SEA VIEW GOLF CLUB COMMITTEE MEETING – 29 JULY 2024

ATTACHMENT A - SEA VIEW GOLF CLUB - CLUB HOUSE REDEVELOPMENT STRATEGY

Sea View Golf Club Facilities Strategy

Figure 16: Concrete spalling on slab

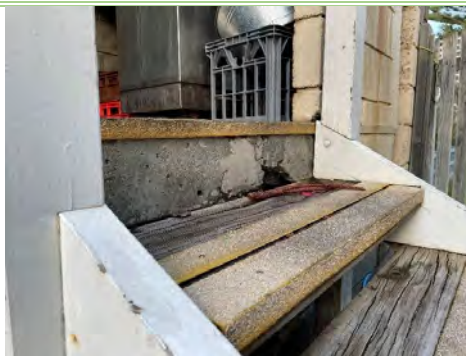
The suspended docking slab shows signs of fair to poor condition, with evident concrete spalling and corroded reinforcement observed at the stair location. Additionally, cracks were evident on top of the suspended slab.

Figure 30: Major cracks on windowsill panel

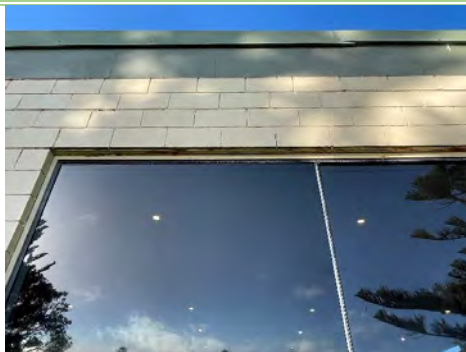
Additionally, significant cracking was observed on the windowsill concrete panel located at the Northeast corner. It is noted that this windowsill panel originally served as a precast balustrade panel as documented in the existing drawings.
